DART SERVICE INSTRUCTION

TO AMEND IIN-D412-704 REV. C OR EARLIER
AND ICA-D412-704 REV. 4 OR EARLIER
REF CANADIAN STC SH93-34
REF FAA STC SR00957NY
REF EASA STC EASA.IM.R.00696

PURPOSE

Figure 5 - Detail L or Figure 25-4 - Detail L

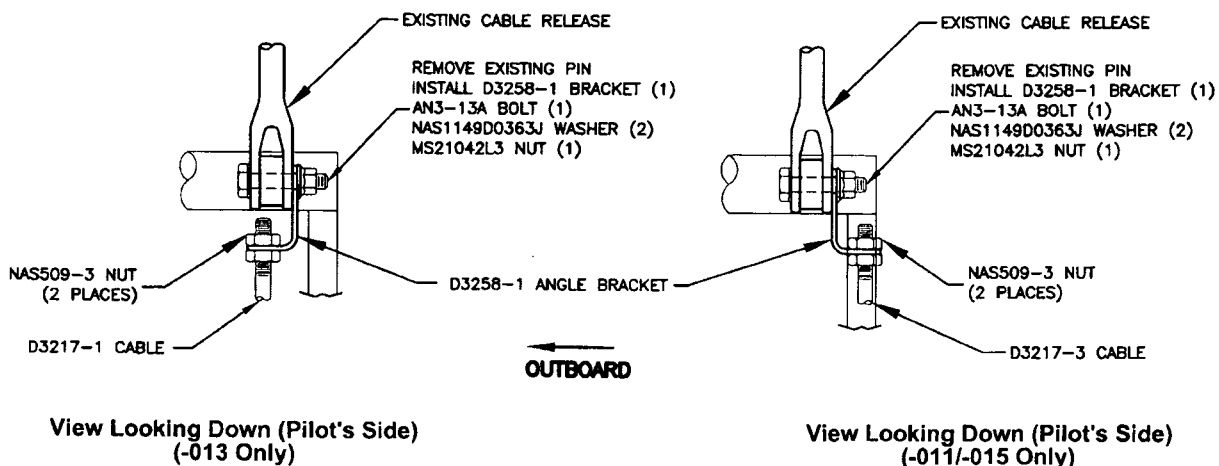
The purpose of this Dart Service Instruction is to correct part number error in Installations Instruction IIN-D412-704 Rev. C or earlier and Instructions for Continued Airworthiness ICA-D412-704 Rev. 4 or earlier. The AN3-13A bolt should be replaced with an AN3-10A bolt in Figure 5 - Detail L in IIN-D412-704 and Figure 25-4 Detail L in ICA-D412-704. See sheet 2.

FIGURES CORRECTION

Revise Detail L Figure 5 of IIN-D412-704 and Detail L Figure 25-4 of ICA-D412-704 as follows:
